EXXEL PACIFIC
GENERAL CONTRACTORS

Subcontract Change Order

Project: 201602. The Cora Apartments (19 W Harrison)
19 W Harrison
Seattle, WA 98109

Change Order #: 3
Change Order Date: 1/31/17
Subcontract #: 201602ONELLC

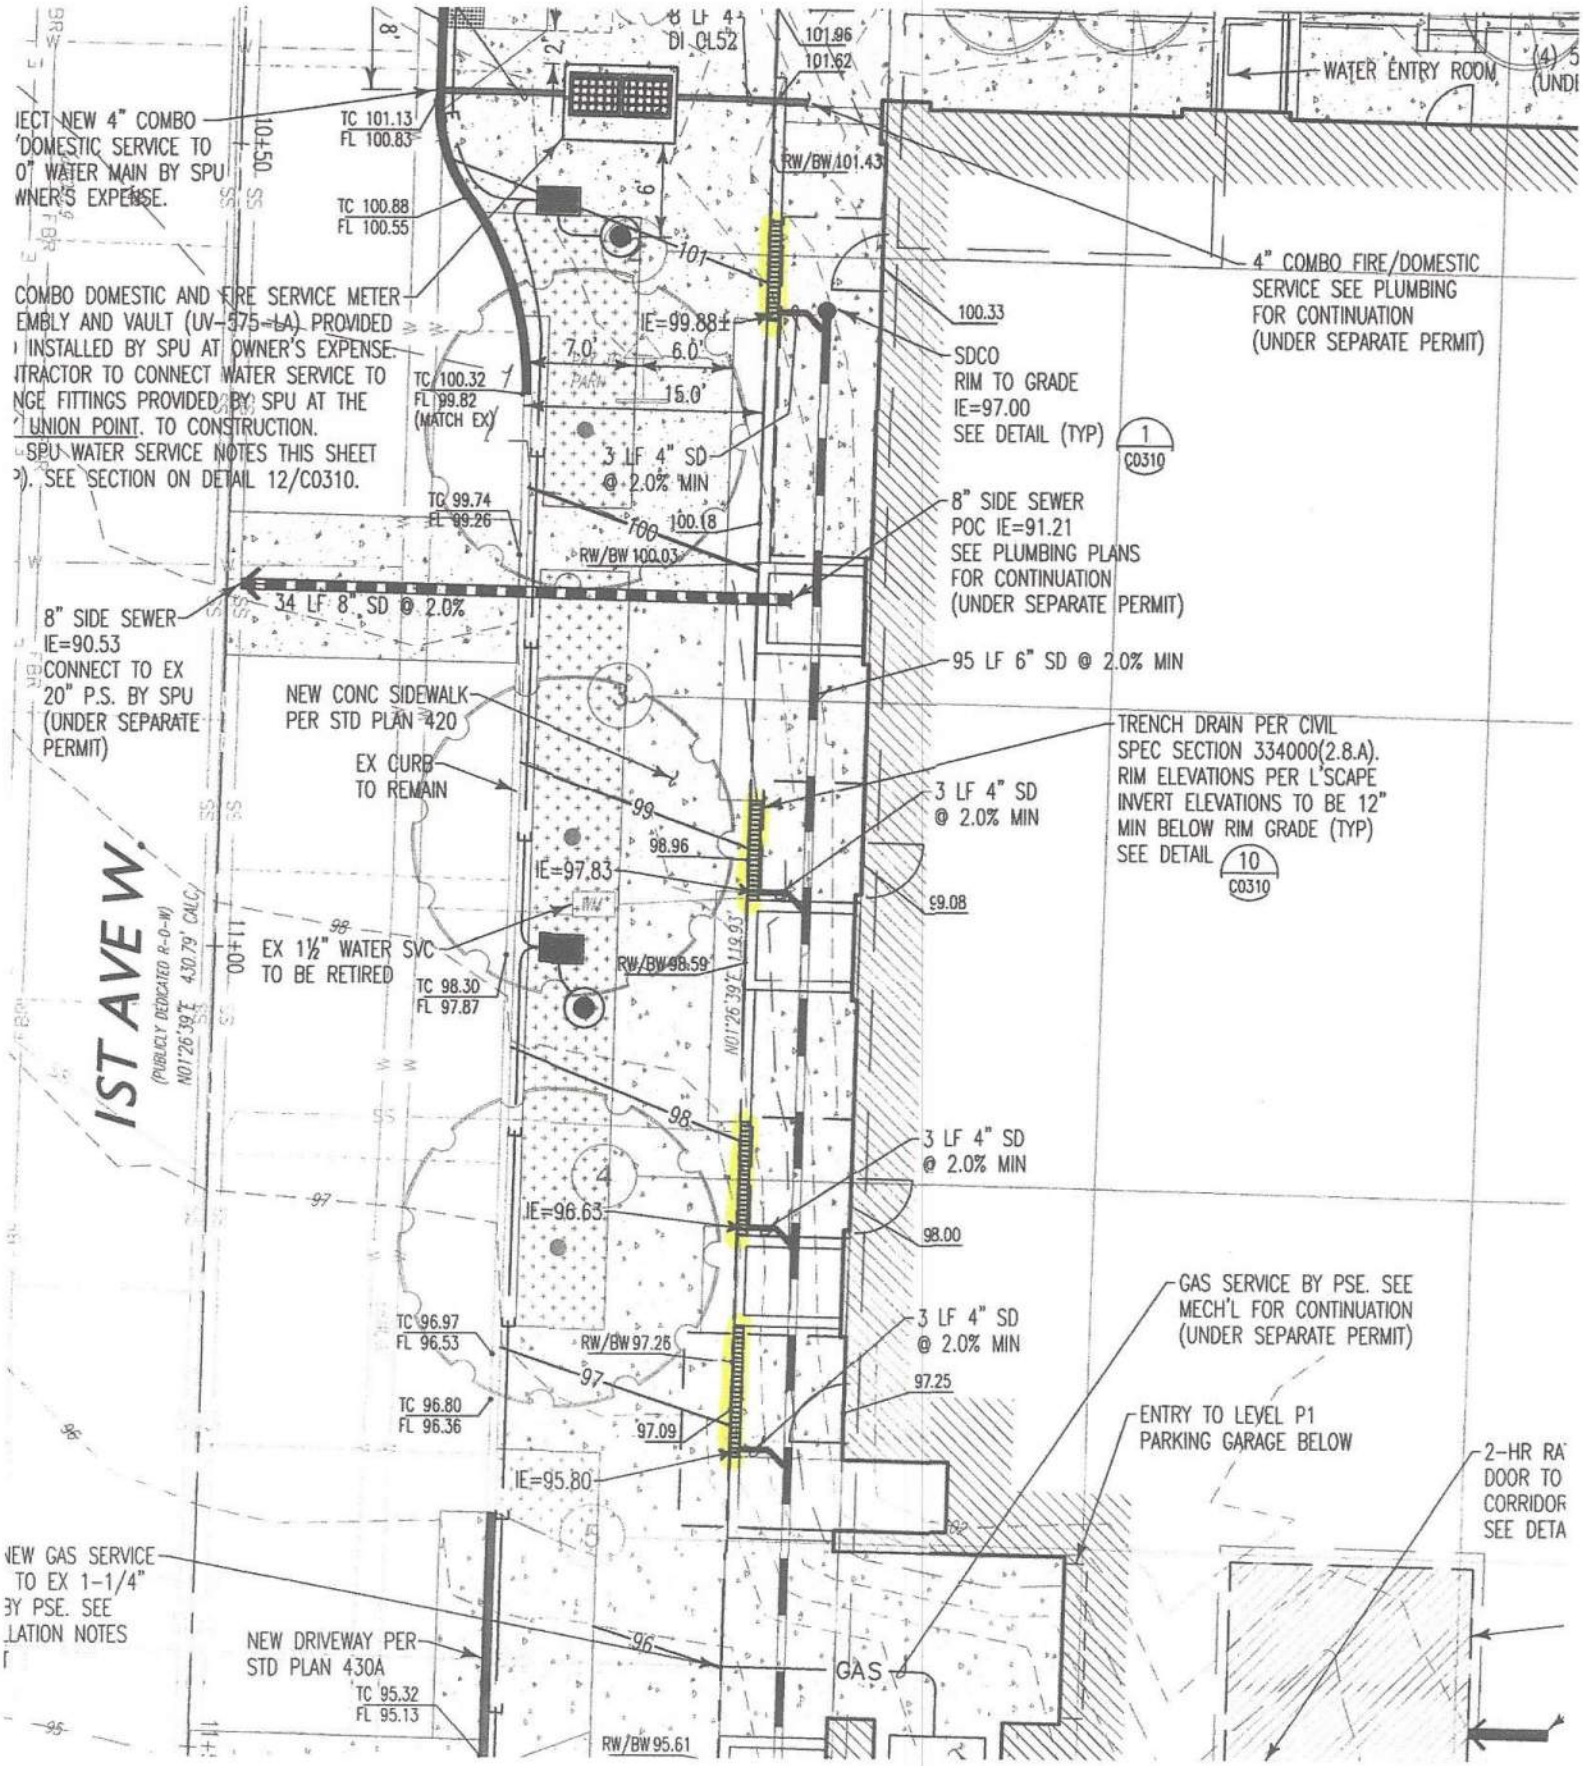
One Way Plumbing, LLC - Added Exterior Trench Drains on 1st Ave.
Reference COR 07 - Install (4) trench drains along 1st Ave. W, as highlighted attached, NDS DS-090N trench drains and DS-226 stainless steel grates per attached submittal. All mainline storm piping is by others. Trenching/excavation is excluded. Fine grading included.
Total Added: $7,881.00 ($6,853.00 + 15% OH&P)

Total cost to install the 4ea trench drains along 1st Avenue West, as highlighted attached, is $$6,853 + 15% OH&P = $7,881. We plan to use NDS DS-090N trench drains and DS-226 stainless steel grates per attached submittal. All mainline storm piping is by others. We will hook up to storm via tee left by others. Trenching/excavation is excluded. We will fine grade only.
